P98-058 - 7-11 Convenience Market - Beer & Wine Sales

- REQUEST:
- A. Negative Declaration
 - B. Mitigation Monitoring Plan
 - C. Special Permit to allow the sale of beer and wine for off-site consumption in a proposed 3,138 sq.ft. 7-11 convenience store with a Citgo gas station on .97± vacant acres in the Heavy Industrial (M-2S) zone.

ATTACHMENT C**NOTICE OF DECISION AND FINDINGS OF FACT FOR
SPECIAL PERMIT TO SALE BEER AND WINE FOR OFF-SITE CONSUMPTION IN A
7-11 CONVENIENCE MARKET/CITGO GAS STATION AT NWC OF FRUIT RIDGE ROAD
AND FLORIN PERKINS ROAD IN THE SOUTHEAST PLANNING AREA IN THE HEAVY
INDUSTRIAL ZONE (M-2S) ZONE. (P98-058) (APN: 061-0173-014)**

FLOOR PLAN
SCALE: 1/4" = 1'-0"

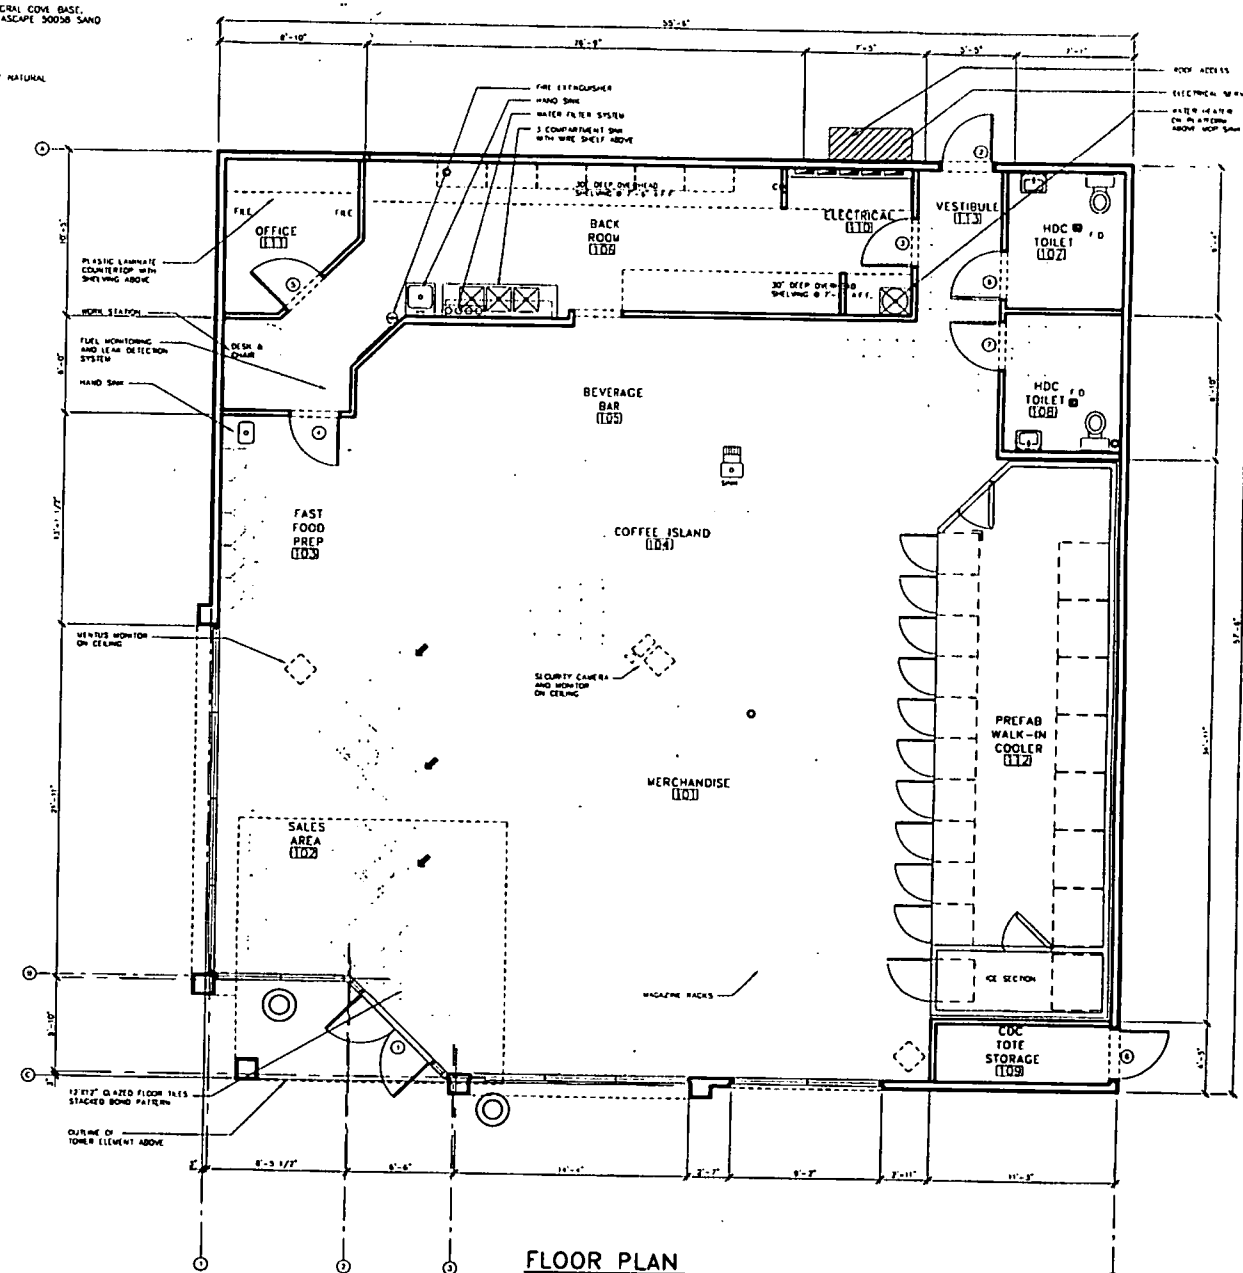
- e) The facility shall be equipped with remote locking devices to enable public entry doorway to be locked from cashier station.
 - f) No over the counter sales racks for cigarette packages or other merchandise shall be permitted.

1 EAST ELEVATION
AS SCALE
1/8"=1'-0"

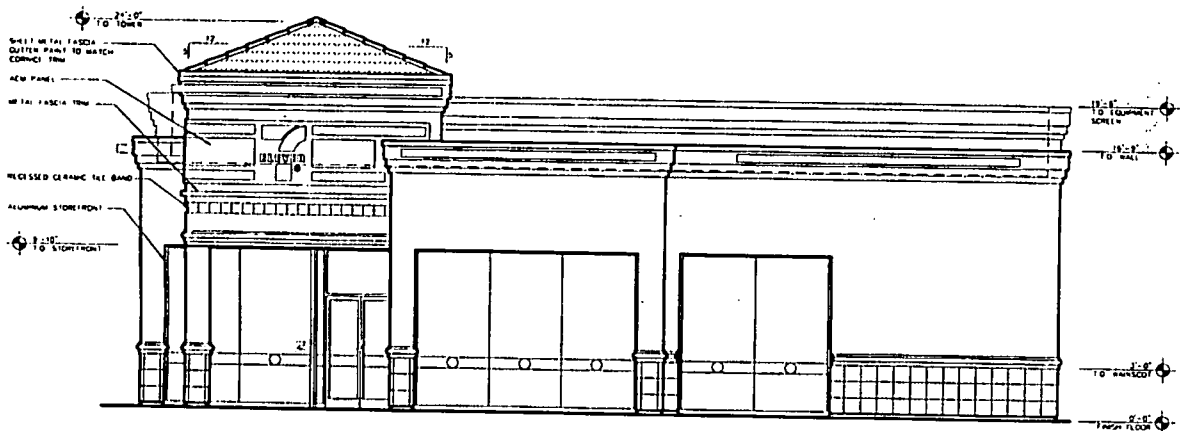
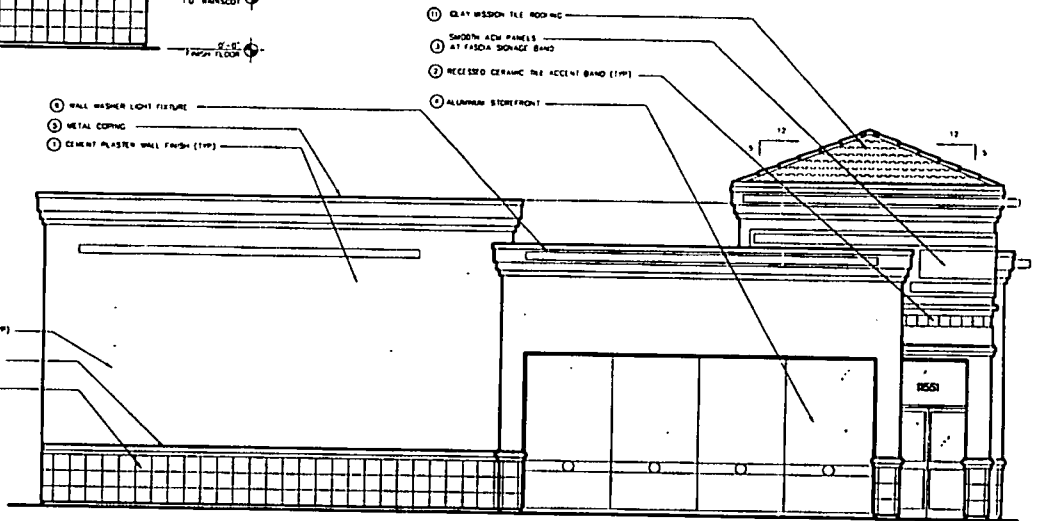
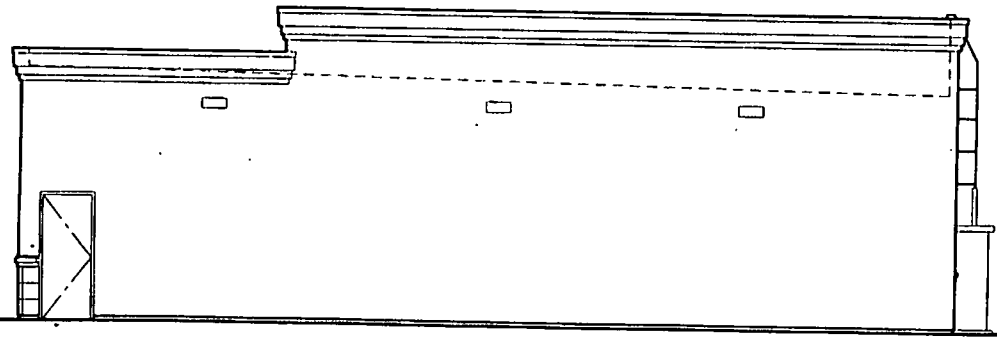
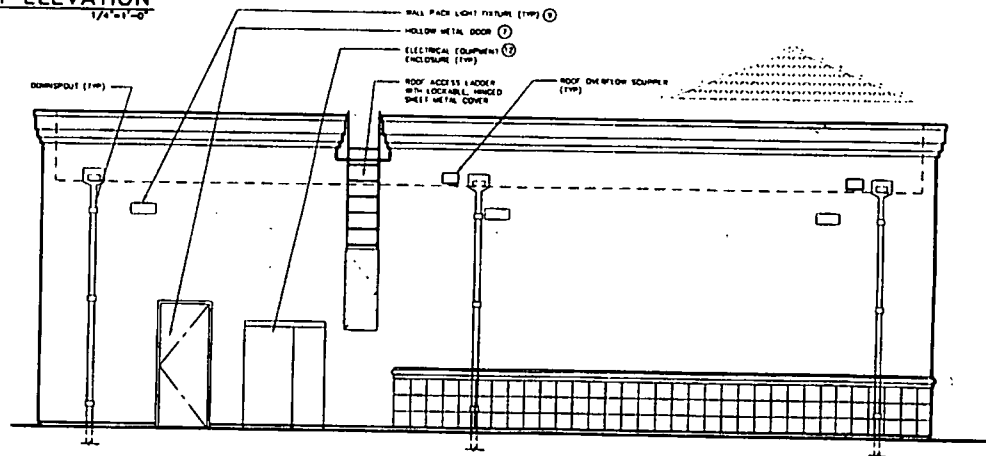
6. The wainscot shall be continued on (north, south, east and west) all elevations of the building.
7. The trash enclosure shall be relocated next to the convenience market. The enclosure shall comply with the City's Trash Enclosure Ordinance and Recycling Ordinance.
